## 9.5 Other Auxiliary Systems

The information in this section of the reference ABWR DCD, including all subsections, tables, and figures, as modified by the STP Nuclear Operating Company Application to Amend the Design Certification rule for the U.S. Advanced Boiling Water Reactor (ABWR). "ABWR STP Aircraft Impact Assessment (AIA) Amendment Revision 3." dated September 23, 2010 is incorporated by reference with the following departures and supplements.

STD DEP T1 3.4-1	STD DEP 9.5-2 (Figure 9.5-3, replaced entire figure)
STP DEP 1.1-2 (Figures 9.5-2, 9.5-4 and 9.5-5)	STD DEP 9.5-3
STP DEP 1.2-2 (Table 9.5-5)	STD DEP 9.5-4
STD DEP 8.3-1	STP DEP 9.5-6 (Figure 9.5-6)
STD DEP 9.4-2 (Table 9.5-5)	STP DEP 9.5-7 (Table 9.5-5)
STD DEP 9.5-1	STD DEP Admin

Figure 9.5-2 Outline - Telephonic Communication System for Single Unit of STP 3 or 4

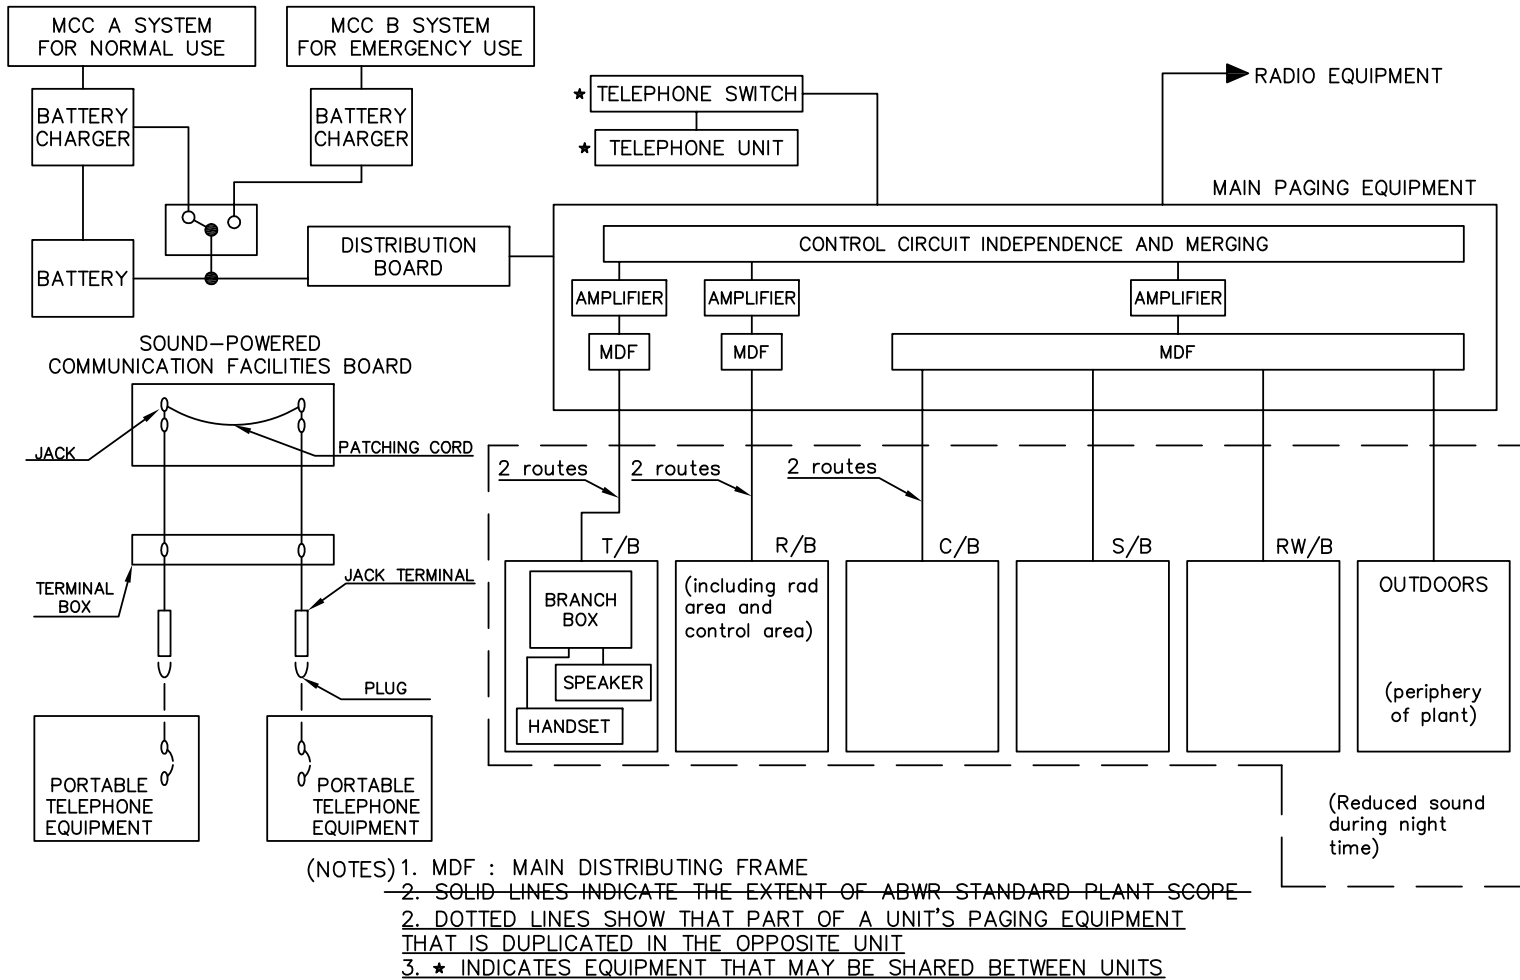
At STP 3 & 4, a common communication system is used to provide plant-wide communications between the dual units. The communication system is not safety-related. A common communication system providing plant wide communications is a safety enhancement since it allows for ease of communication between units. The representative outline of the common communication system is shown in Figure 9.5-2 for STP 3 & 4.

Figure 9.5-3 Lower Drywell Flooder System Arrangement/Configuration

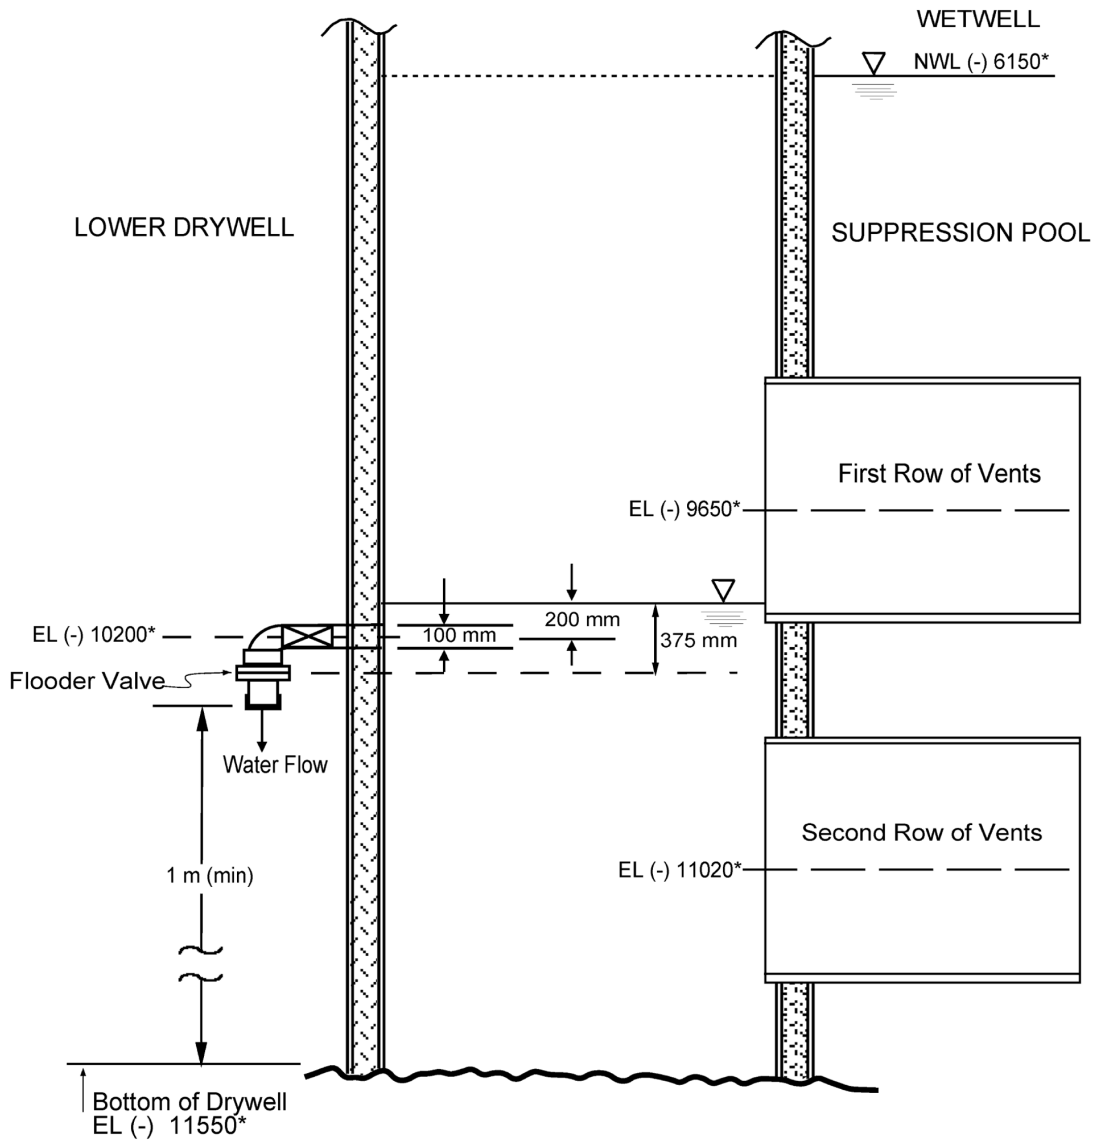
The LDF, shown schematically in Figure 9.5-3, provides a flow path for suppression pool water into the lower drywell area during severe accident scenario that leads to core meltdown, vessel failure, and deposition of molten corium on the lower drywell floor. Molten corium is a molten mixture of fuel, reactor internals, the vessel bottom head and control rod drive components. The flow path is opened when the lower drywell airspace temperature reaches 260°C.

The LDF consists of ten pipes that run from the vertical pedestal vents into the lower drywell. Each pipe ~~contains~~ has an isolation valve and a fusible plug valve connected to the end of the pipe that extends into the lower drywell ~~by a flange~~. The fusible plug valves open when the drywell air space ~~(and subsequently the fusible plug)~~ temperature reaches 260°C. When the fusible plug valves open, a minimum of 10.5 L/s of suppression pool water will be supplied through each floodor pipe (105 L/s total) to the lower drywell to quench the corium, flood the lower drywell and remove corium decay heat, which is estimated at 1% of rated thermal power. The flow rate is based on a minimum hydrostatic head of 200 mm above the floodor pipe inlet centerline and takes the frictional losses through the floodor pipe and fusible plug valve into account.
